COMMENTS MATRIX

Draft IS-GPS-800, dated 6 April 2006

Figure 3.2 – 1A. Example GPS PRN L1Cp Signal Number 4

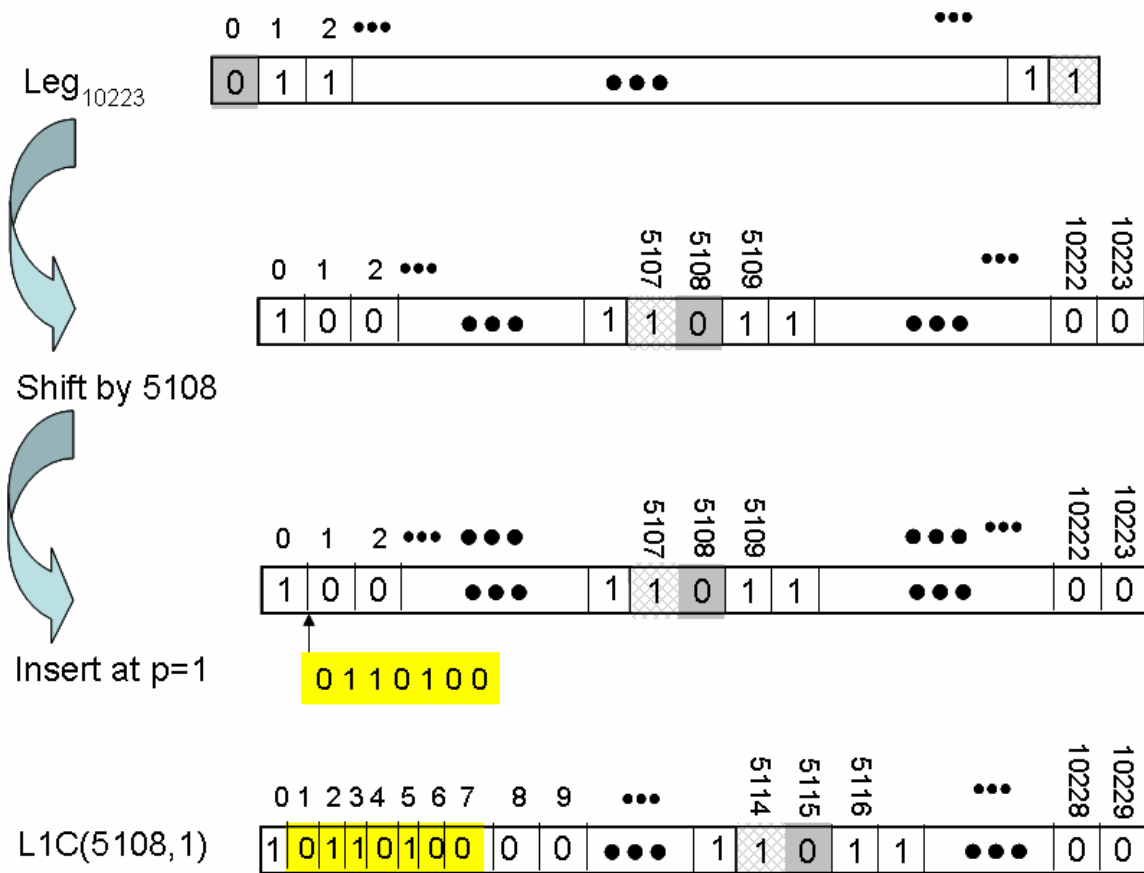
22	S	<p>Page 18, Figure 3.2-1 Comment: Figure is not clear. We suggest add the following Figure after Figure 3.2-1.</p> <p>Figure shown on next page.</p>	D: Figure 3.2-1, together with equations of Section 3.2.2.1.1, should provide clear description of the algorithm. The figure attached to this comment is not an accurate depiction of the algorithm. The current figure in the IS will be further evaluated for any possible update.
23	S	<p>Page 5, para 5, line 1: Comment: Recommend adopting BOC(1,1) and not TMBOC technique Suggested Change: Delete from “OR” to end of paragraph Rationale: Simplify SS-US Interface. This technique does not appear to provide any benefit to our user base</p>	D: This comment will be considered in the decision process of the GPS JPO.
